#2021-66
GW Properties Wendy's and Guzman Y Gomez –
Preliminary Planned Unit Development
Project Review for Planning and Zoning Commission

<u>Meeting Date:</u>	June 2, 2021
<u>Request:</u>	Preliminary Planned Unit Development two new limited service restaurants.
<u>Location:</u>	5459 and 5501 Northwest Highway
<u>Acreage:</u>	Approximately 2.6 acres
<u>Existing Zoning:</u>	B-2 PUD General Commercial Planned Unit Development
<u>Surrounding Properties:</u>	North: B-2 PUD General Commercial South: M Manufacturing (Three Oaks Recreation Area) East: B-2 PUD General Commercial West: B-2 PUD General Commercial
<u>Staff Contact:</u>	Elizabeth Maxwell (815.356.3615)

LANDSCAPE PLAN
SCALE: 1" = 20'-0"

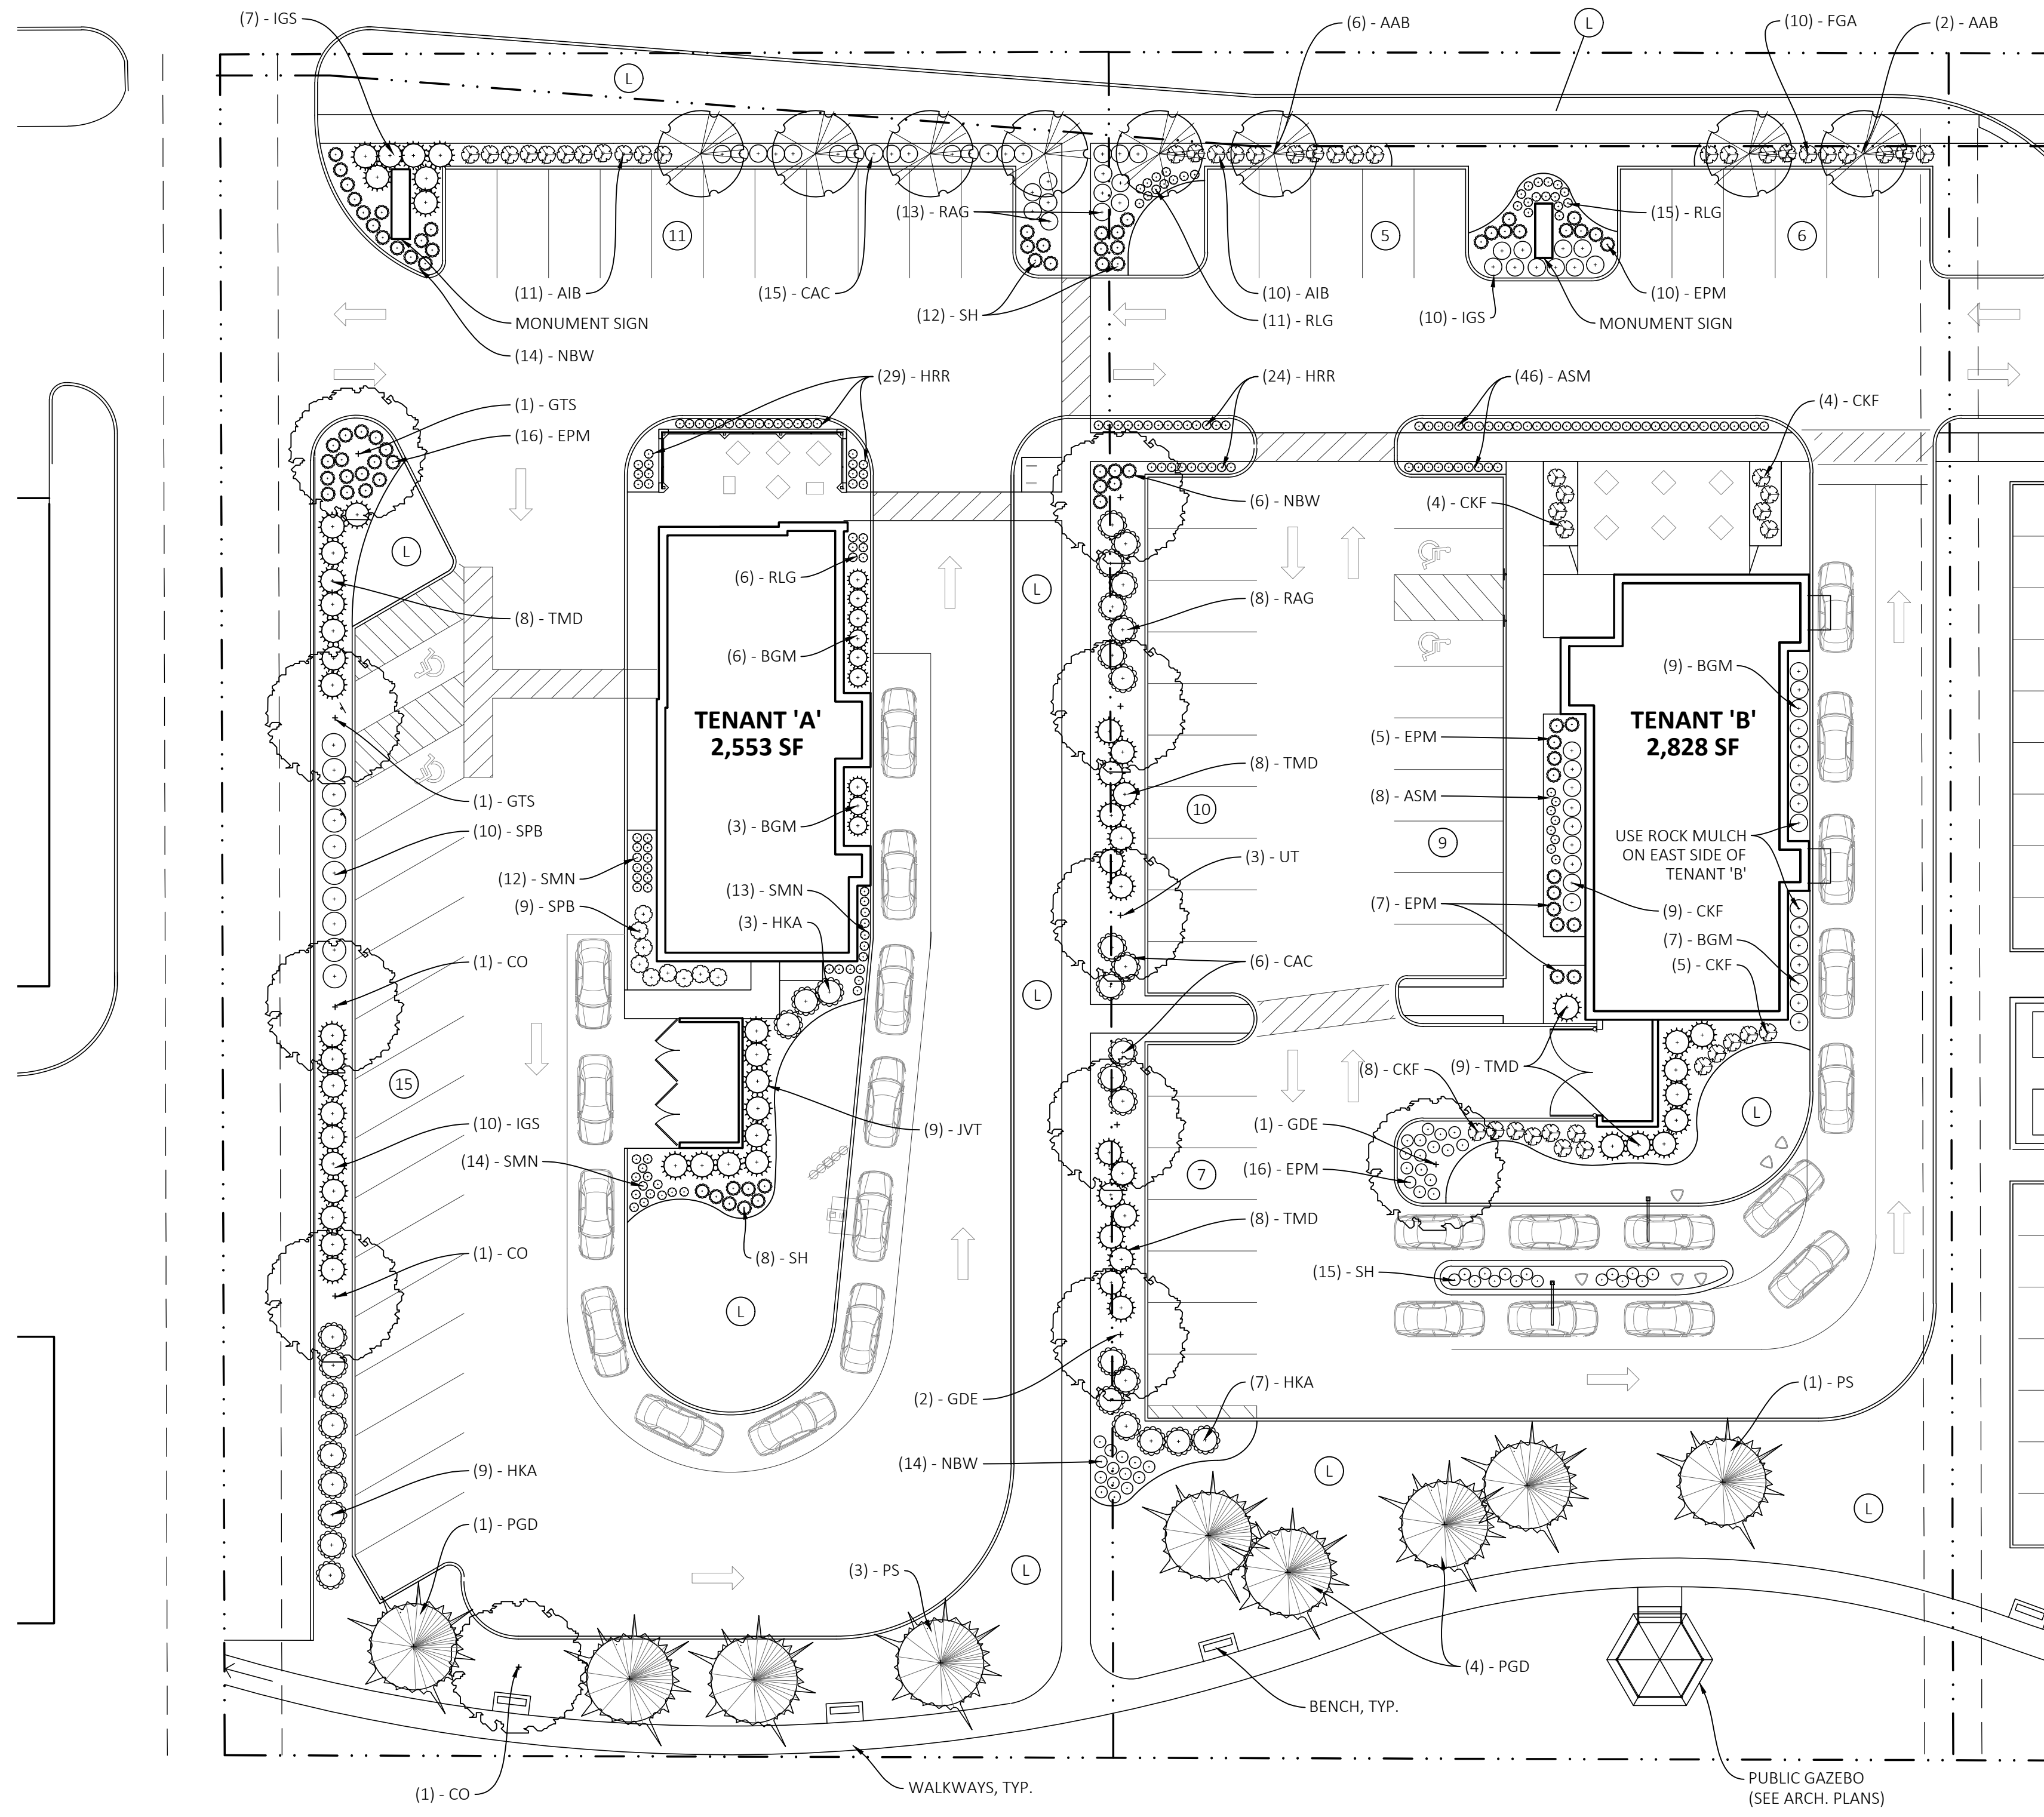
- Landscaping parking lot screening strip is provided along the western perimeter of the Wendy's site. This strip takes the place of islands every 10 spaces. Additional landscape needs to be added to this area to meet the requirements, including 2 trees and 7 shrubs.
- Foundation Base plantings are required around the building at a minimum of 5 feet in width. Wendy's is not showing any plantings along the center to northern portion of the west side of their building and there is only a 3-foot area adjacent to the outdoor patio area. Opportunity for additional foundation base landscape exists.

- Due to the necessary dedication of right-of-way for a deceleration lane, the minimum 20-foot parking lot setback and 15-foot landscape setback between the site and Route 14. The setback tapers from 14 feet to 8 feet along the Wendy's property line and to 4 feet along the Guzman Y Gomez property line. Guzman Y Gomez has tried to meet the intent of the ordinance by installing extra-large islands at the ends and center of their front parking row.

- Within the 20-foot area reserved for the future boardwalk are some Spruce and Eastern White Pines and a Hackberry.
- The two lots have done a good job designing the landscape plan so that there is material disbursed throughout the site. Plantings have been included between the various users, along the north and south property lines, as well as around the individual buildings. Landscape materials help soften the impact of built surfaces and reduce impervious surface runoff.

3. Landscape Plan
 - A. Small deciduous and medium evergreen trees are required around the monument signs.
 - B. Wendy's to look at options to providing foundation base landscape along the west and north sides including possibly adding planters.
